AIA[®] Document G716[™] – 2004

Request for Information (“RFI”)

Harrison, Town-Village Recreation Center Phase 2
270 Harrison Avenue
Harrison, NY 10528

ISSUE DATE: 03/20/2025 **RFI No.** 051 - Phase 1 Conduit Rework

1
PARKING FLOOR PLAN PHASE 1
SCALE: 1/8" = 1'-0"

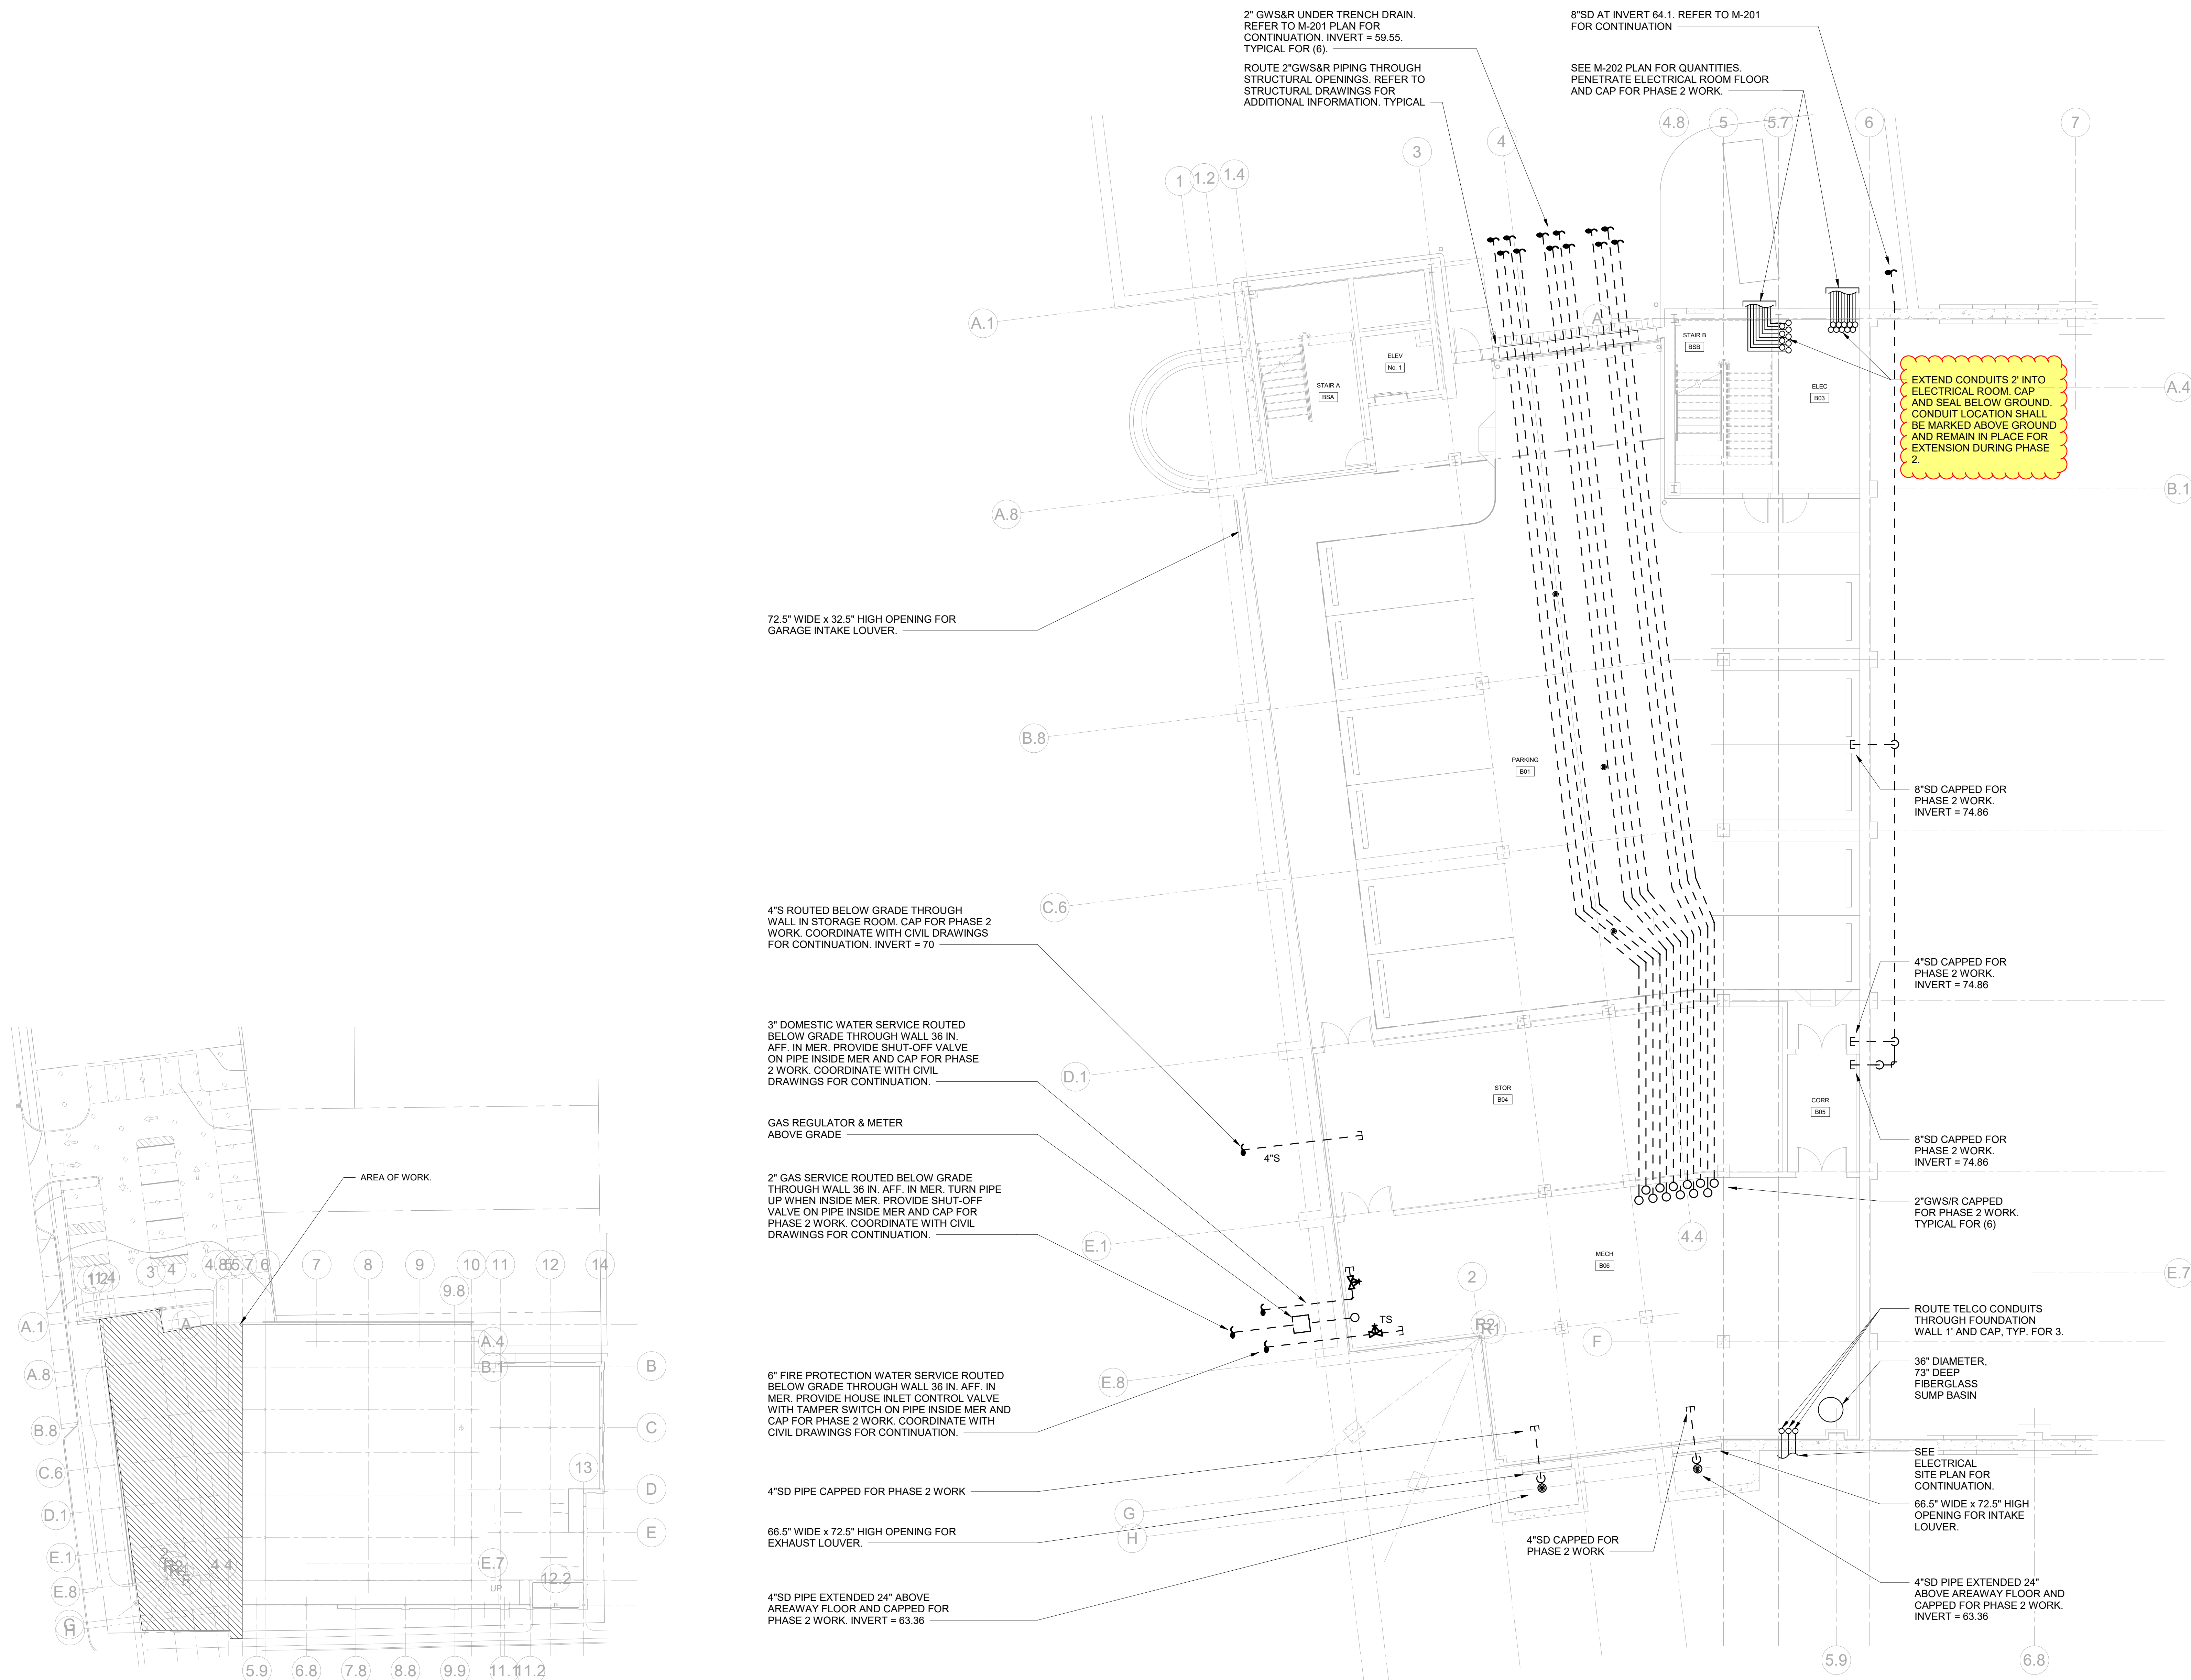
Based on our reviewing of the Phase 1 conduit installation, we have identified a few issues that need to be addressed.

1. Generator Conduit Issue:

The conduits installed for the generator were based on an different generator layout and do not match with our approved generator model. As a result, they will need to be redone to be stubbed up at the right location.

2. Electrical Room Conduit Termination:

The conduits installed during Phase 1 were originally intended to be run all the way to the electrical room. However, they currently terminate at the foundation wall within the staircase instead. These would have to be extended to the electrical room. This is not part of our contract and would be an extra to us (See attached phase 1 drawing for reference).

Attached is the updated drawings for the phase 1 work showing the our work in to the electrical room. Please advice on how you would like to proceed with this issue. Also, we have determined that core drilling/slab cutting of the foundation wall will not be required, as previously anticipated.

The generator conduits were intended to be left below grade in Phase 1 to accommodate the eventual Phase 2 generator install. Remove the above grade conduit to a point at or below grade as necessary to allow for the conduits to be extended to the generator in the appropriate configuration.

As stated the conduits were incorrectly terminated outside the building perimeter by the Phase 1 contractor. On a Time and Material basis please extend the conduits from their current location into the Electrical Room to the locations required by the previously approved (Phase 2 electrical subcontractor) equipment layout. Utilize the notch created in the foundation wall that currently exists from Phase 1 to enter the building perimeter. A separate directive will be issued for the infill/header detail to complete the concrete foundation wall at that location. It is the intent that the conduit work can commence upon receipt of this RFI response.
